PROPOSED TECHNICAL SPECIFICATION REVISIONS
BROWNS FERRY NUCLEAR PLANT
UNIT 1 RELOAD 5
(TVA-BFNP-TS-190)

PART I - CORE RELOAD CHANGES

PART II - PLANT MODIFICATION RELATED CHANGES

ENCLOSURE 2
DESCRIPTION AND JUSTIFICATION
TVA BFP TS 190
BROWNS FERRY NUCLEAR PLANT
UNIT 1 RELOAD 5
PART I - CORE RELOAD CHANGES

Figure 3.5.K-1

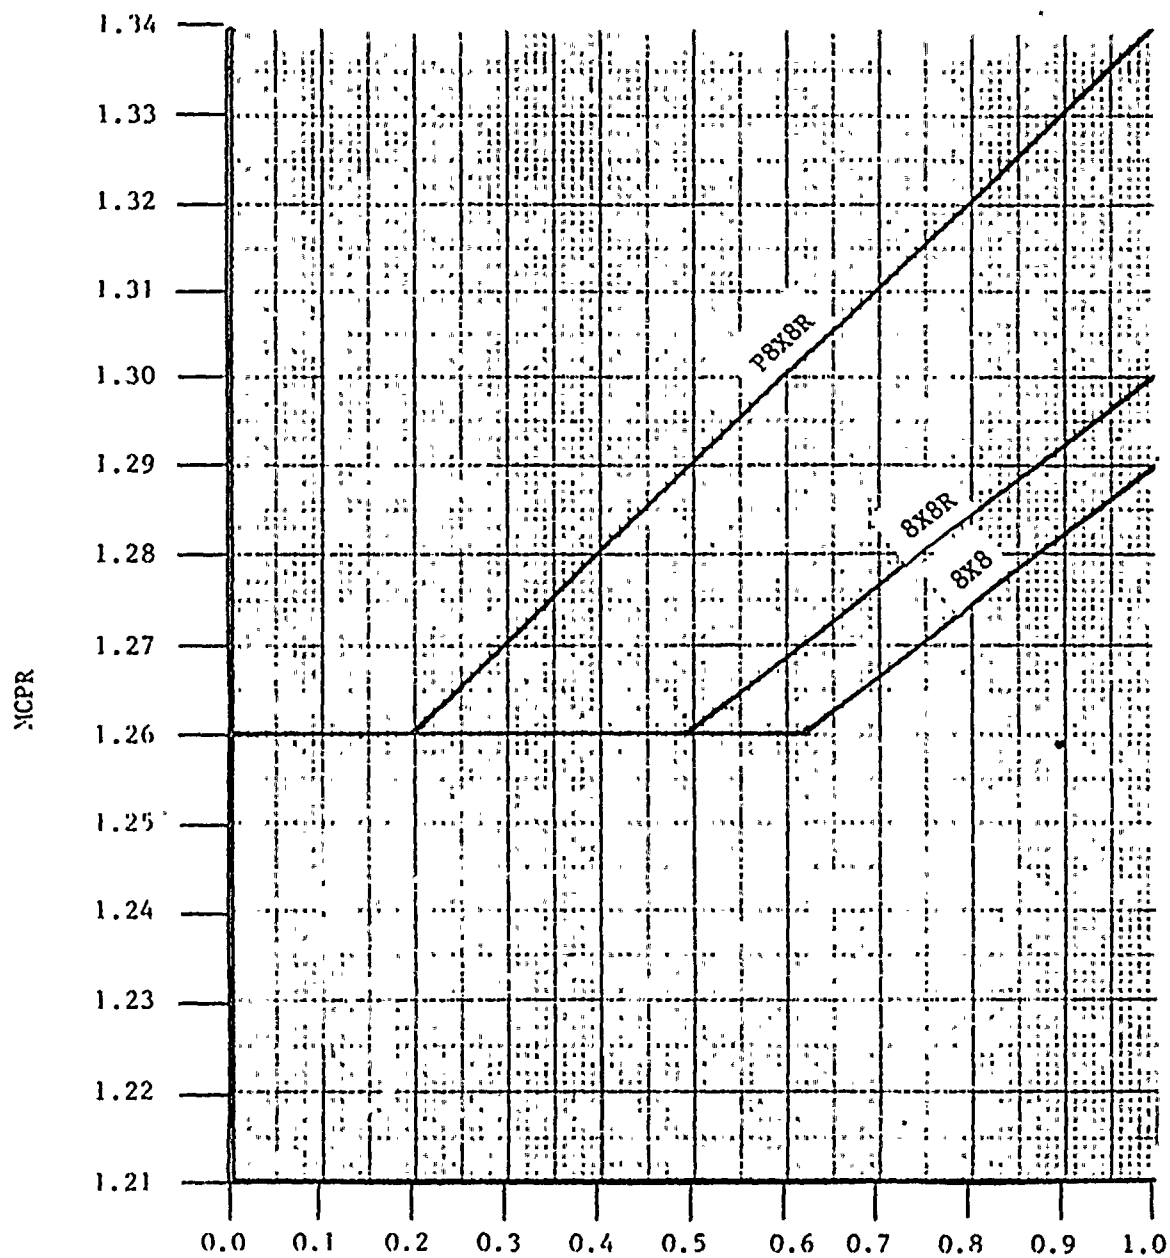
Page 172b, figure 3.5.K-1 - The operating limit MCPRs are being revised to reflect the adjusted MCPR values for all events provided in the unit 1 reload 5 supplemental licensing submittal.
